File FP-1996-055

Name: James Park Final Plan – NE corner 28 ¼ Road and Gunnison Avenue

Noise Wall Plan

LANDSCAPE PLAN

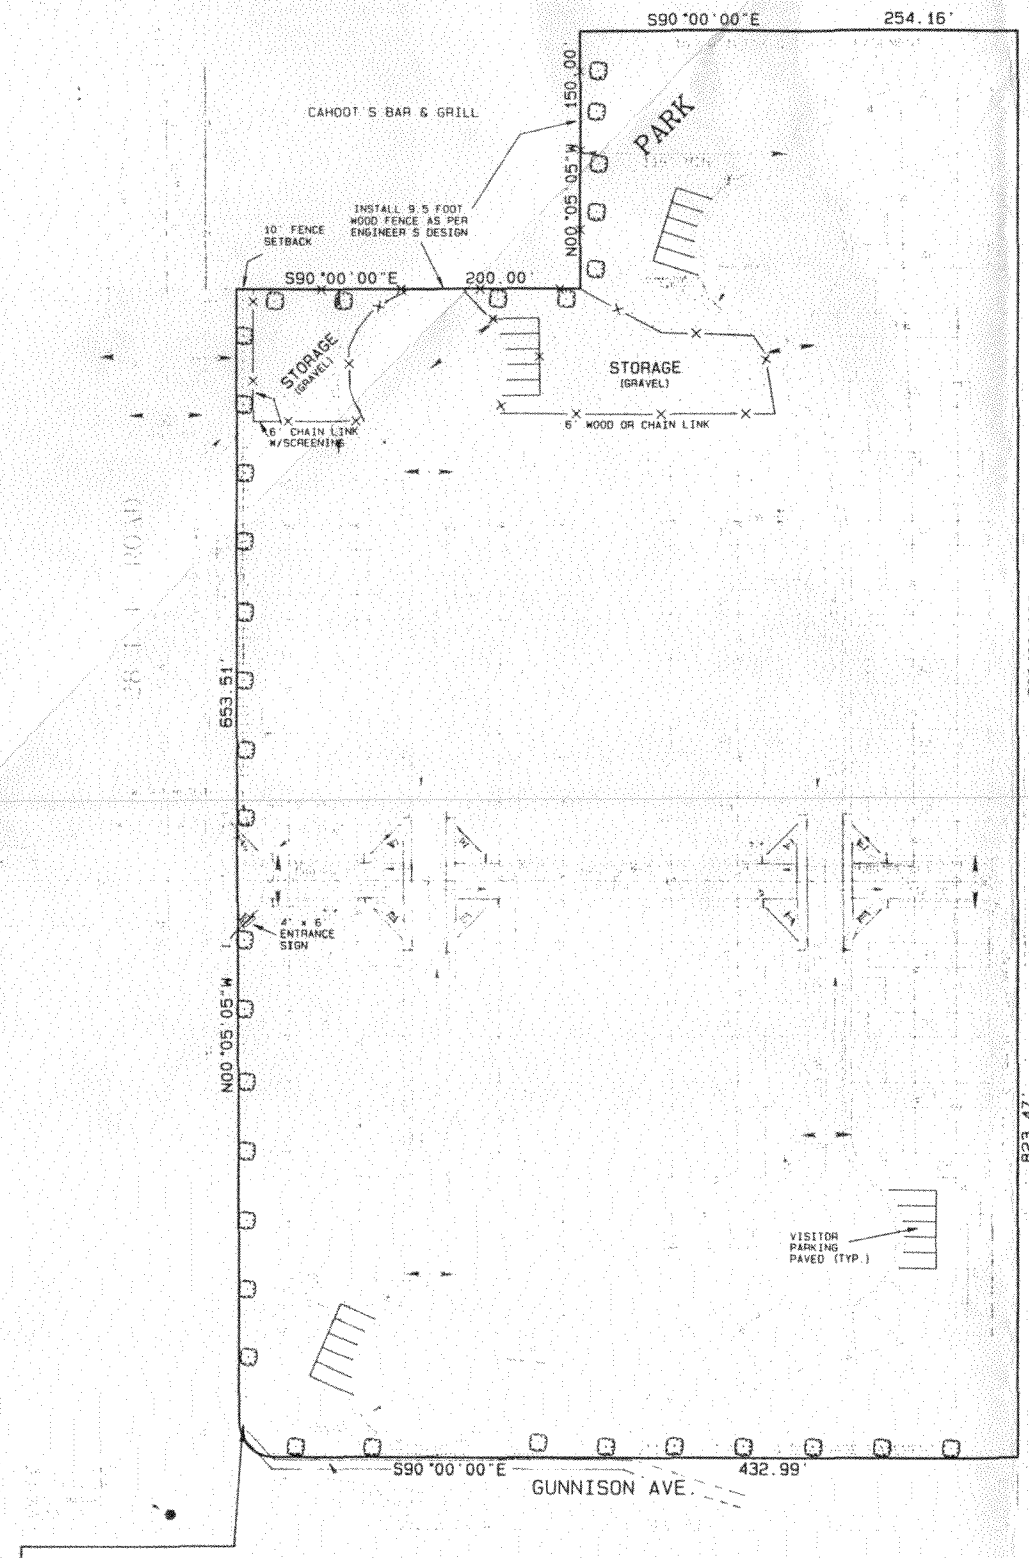
4. Revise the landscape drawing to include the planting of at least 5 large trees along the west property line adjacent to Cahoots, in accordance with condition #9 of preliminary approval. Place a note on the plan that states that the trees will be at least 1.5 inches in caliper and 10-15' in height at the time of planting. A species must be selected that will reach a height of at least 50'.

5. Where is the detailed landscape plan showing that at least 10' of the perimeter street setback along 28 1/4 Road (and Gunnison) will be landscaped, as required in condition #6d? Tree spacing must be no more than 40' - the trees shown on your landscape plan are spaced from 60' to 90'. Submitted landscape plan does not meet SSID submittal requirements.

- 1.) A 10 foot strip along 28 1/4 Road and Gunnison Ave. will be landscaped with bluegrass seed and Cottonless Cottonwood trees (Populus Angustifolia) of at least 1.50 inches in caliper and a minimum of 4 feet in height at the time of planting. These trees will be spaced no further than 40 feet apart.

- 2.) The landscaping along Gunnison Ave. will not take place until Gunnison Ave. has been improved.
- 3.) Five Cottonless Cottonwood trees (Populus Angustifolia) will be planted along the west property adjacent to Cahoot's of at least 1.5 inches in caliper and 10 to 15 feet in height at the time of planting.

FENCE DETAIL-PLAN VIEW
NO SCALE

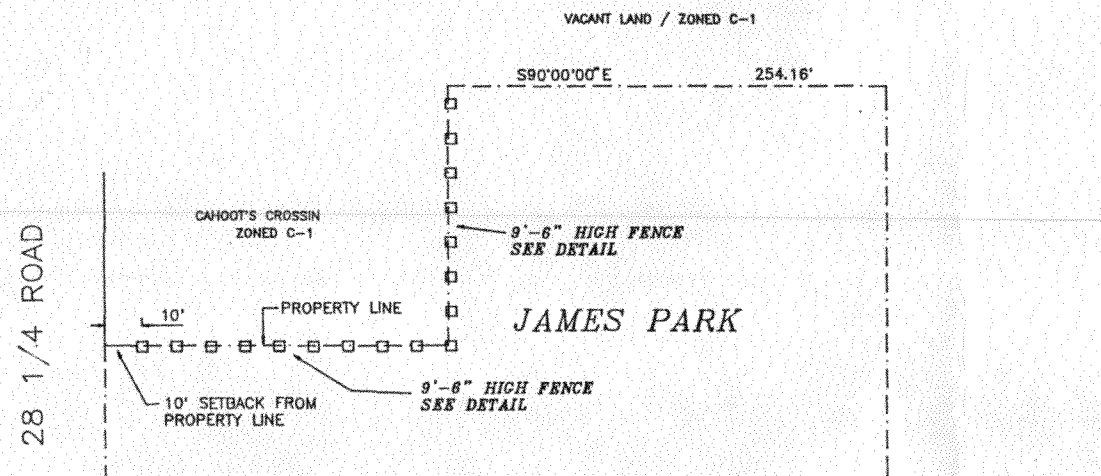
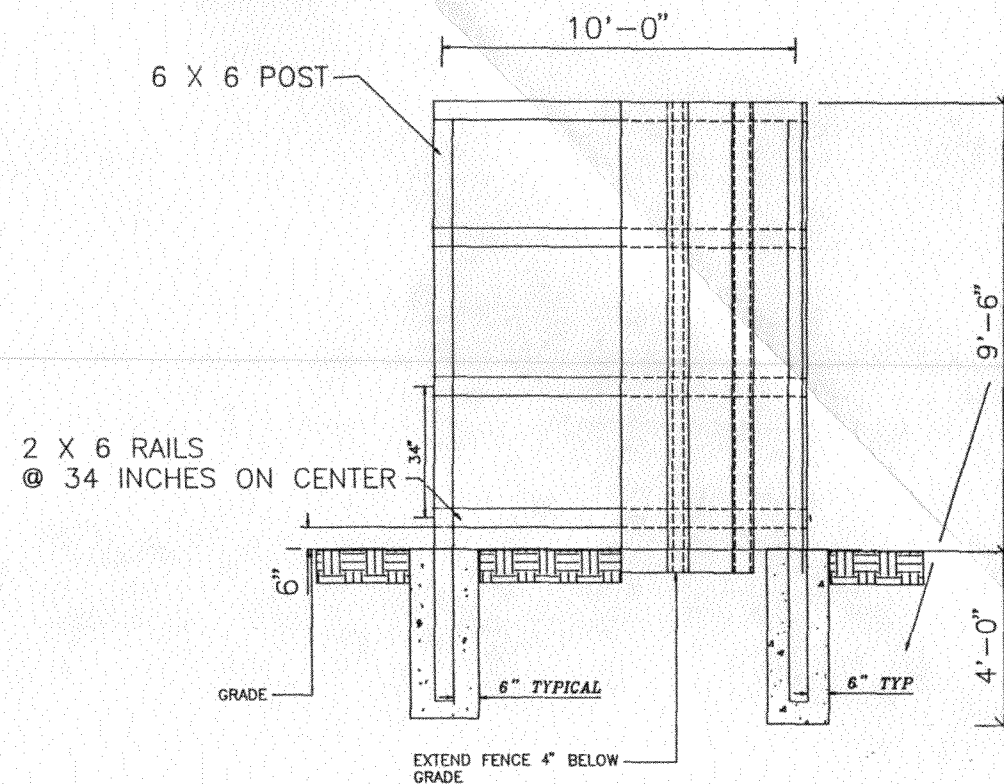
1. The fence detail sheet submitted by Wayne Lizer presents conflicting information. The fence detail shows the fence 9.6' high, the overall view shows the fence 12' high. The fence detail shows a supporting 2 X 6 rail every 4 feet, but the fence is only 9.5' high.
2. I don't believe the proposed fence detail meets the criteria proposed by David L. Adams Associates, Inc. The detail doesn't show that the fence slats are extended below grade. It also doesn't show wood battens to cover picket spacing. It appears that the recommended design for the pickets required 2" lumber. Your design is proposing 1" lumber nailed to 2" rails spaced 4' apart.

SITE PLAN

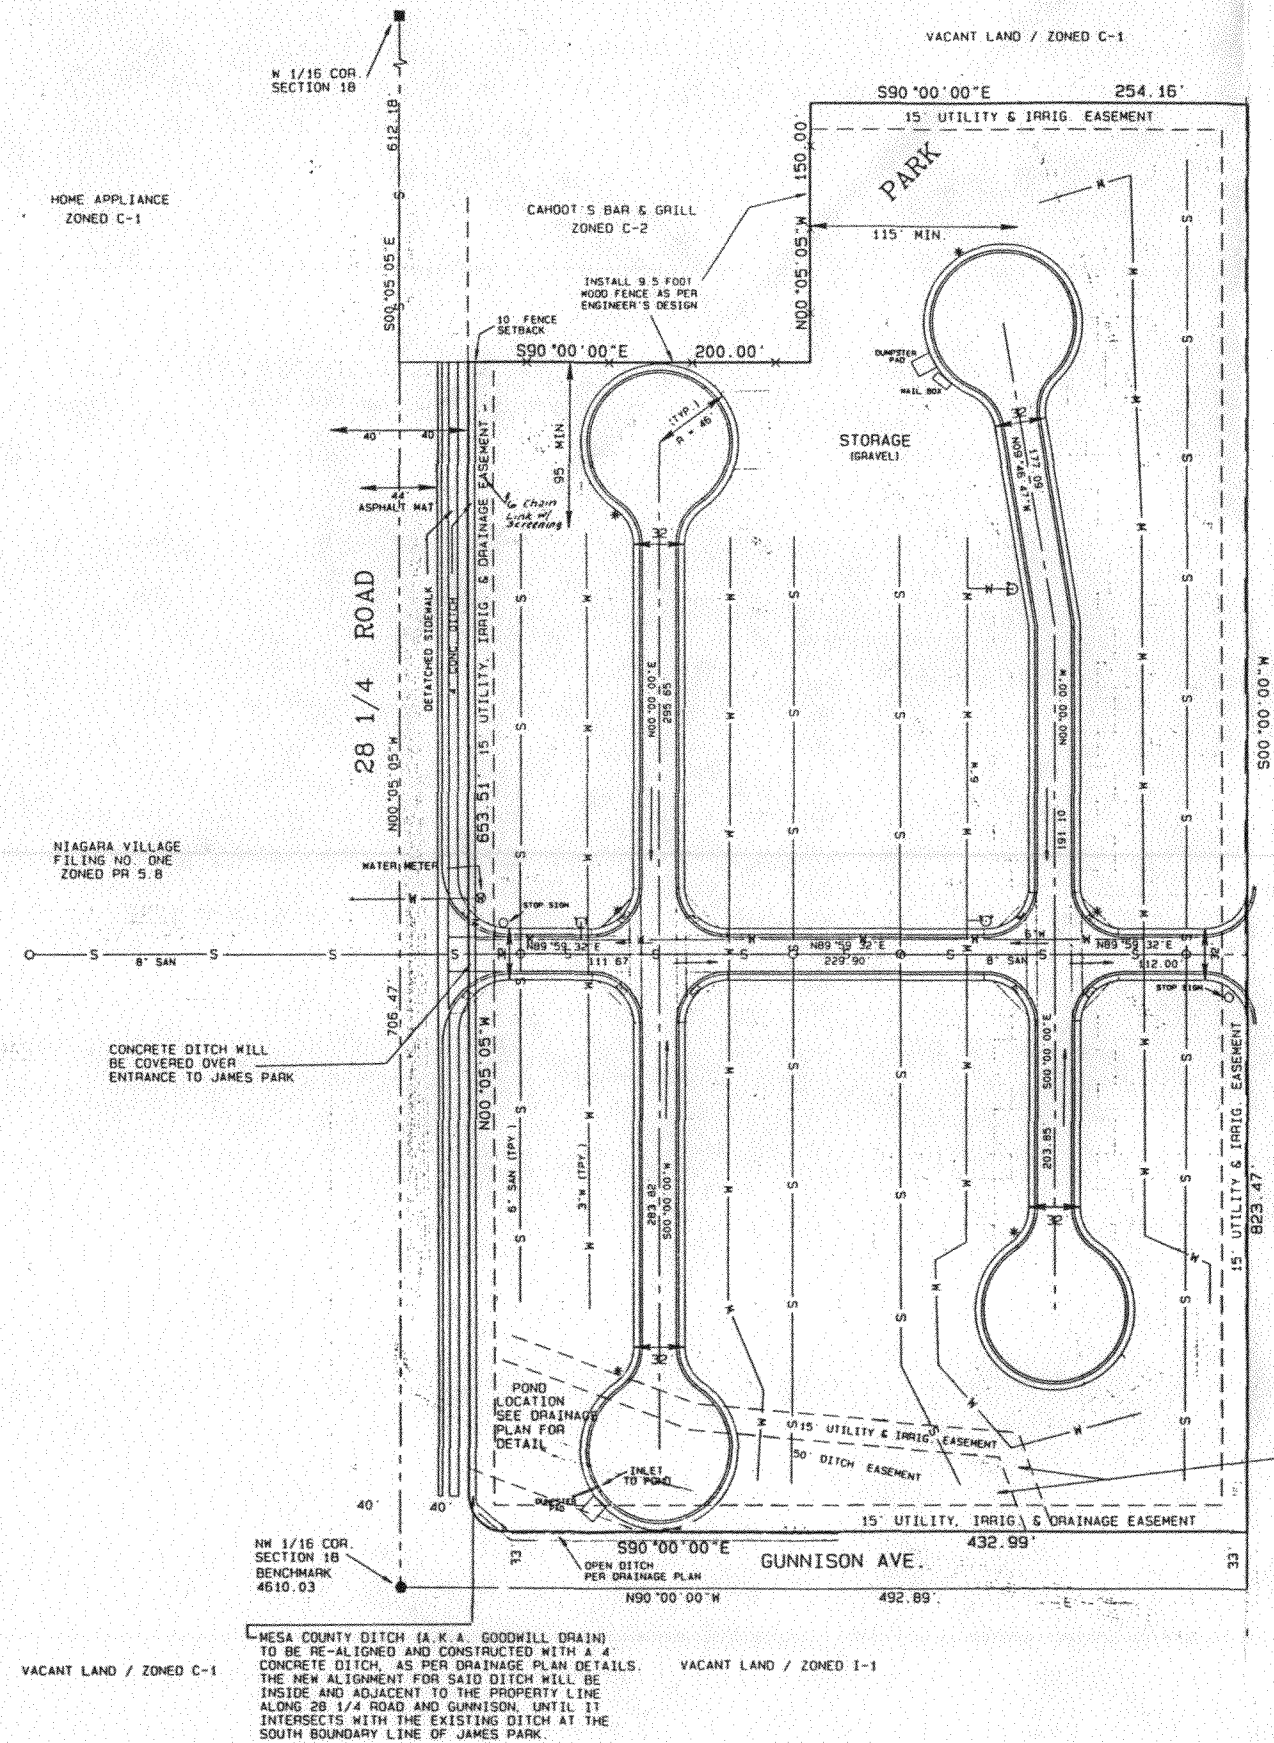
2. Perimeter setbacks as required in condition #6c have not been addressed. Space 25 is encroaching in the 15' setback to Gunnison.
3. Revise the drawing to show that the residences in spaces 1 and 55 are no closer than 95' to the south property line of Cahoots, in accordance with condition #8 of preliminary approval.

12. The site plan does not show the 15' utility & irrigation easement along the north line of the Goodwill Drain, along the south property line. Has this easement been vacated? If not, remove the structures (mobile homes & carports) from within this easement.

REC 5-1-96
 Changed from submitted plan
 APPROVED BY CITY ENGINEER: _____
 DATE: _____

JAMES PARK GRADING AND DRAINAGE PLAN

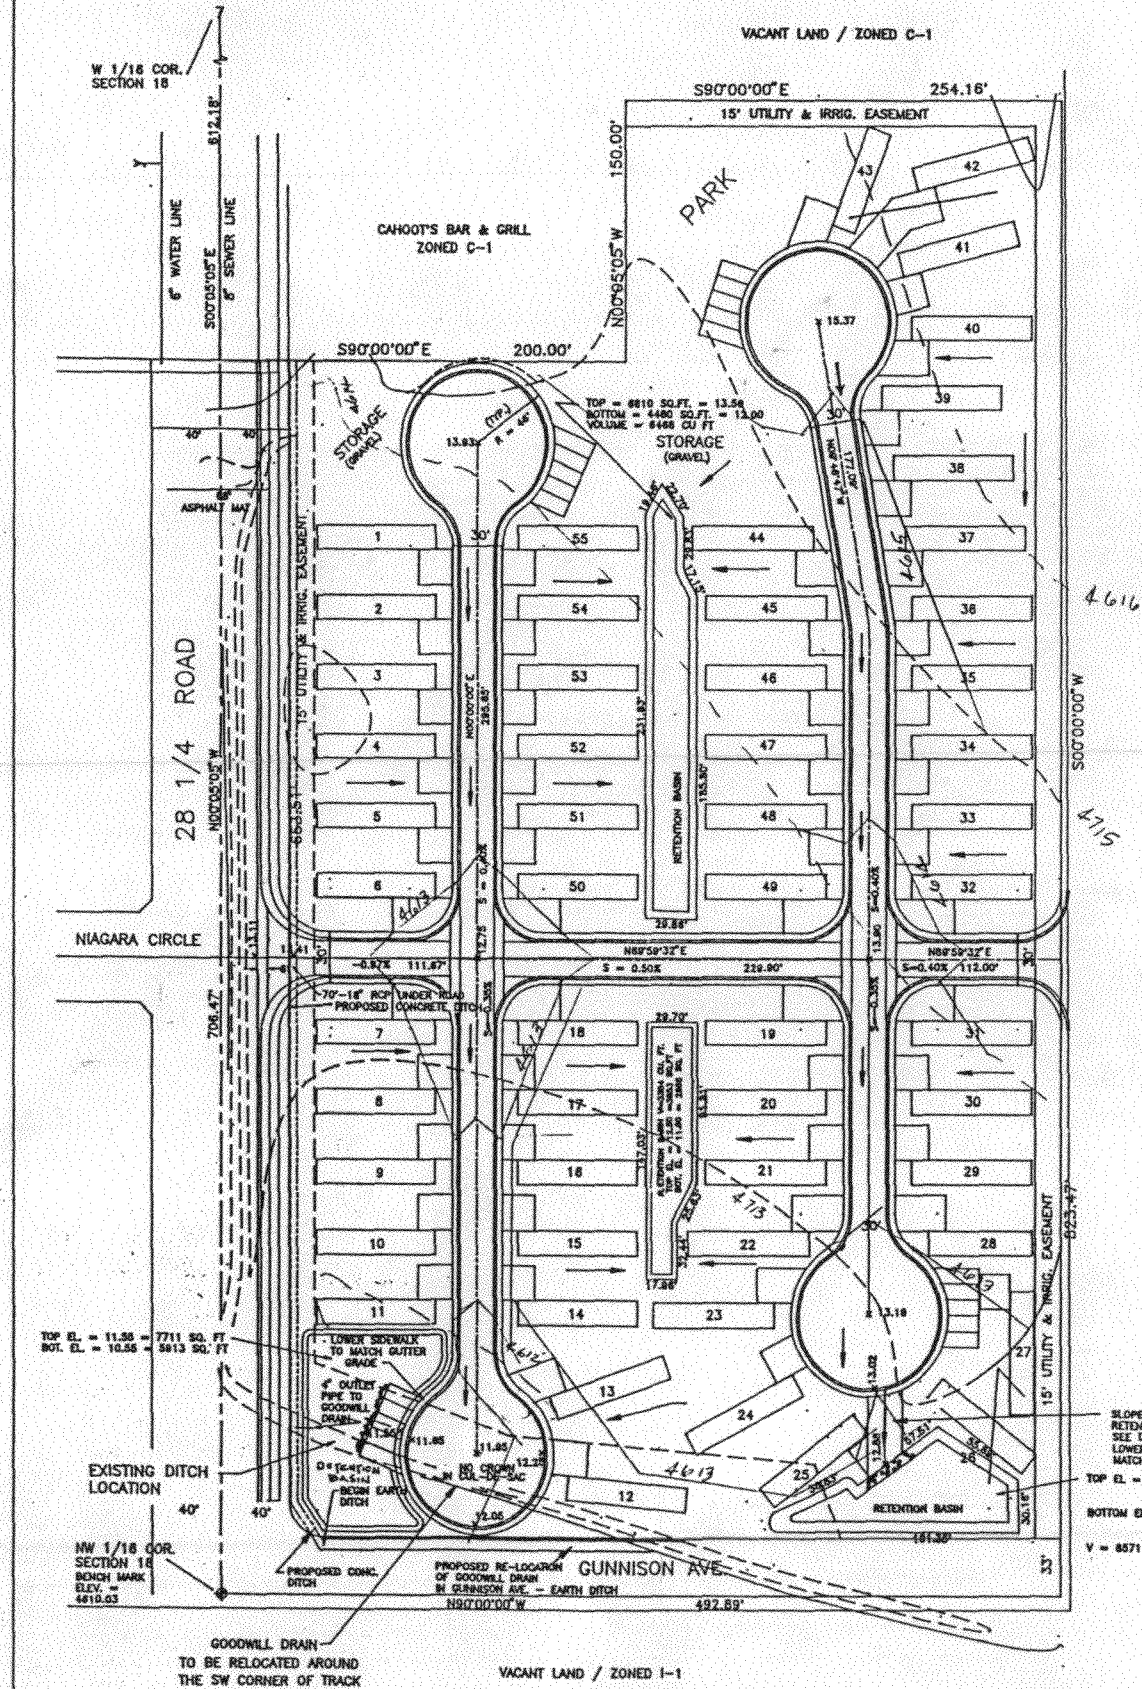
10	Space for approval signature by City Engineering with date and title		
	<p><i>TWO PLANS WERE SUBMITTED - THESE CONFLICT WITH EACH AND ARE NOT CONSISTENT. WHICH IS THE REAL PLAN?</i></p>

The storm water management plan on one sheet identifies the pond as a detention pond and on the other as a retention pond. A retention pond uses evaporation to move the water. A detention pond has an outlet. There is a design for an outlet structure, so the pond must be a detention pond.
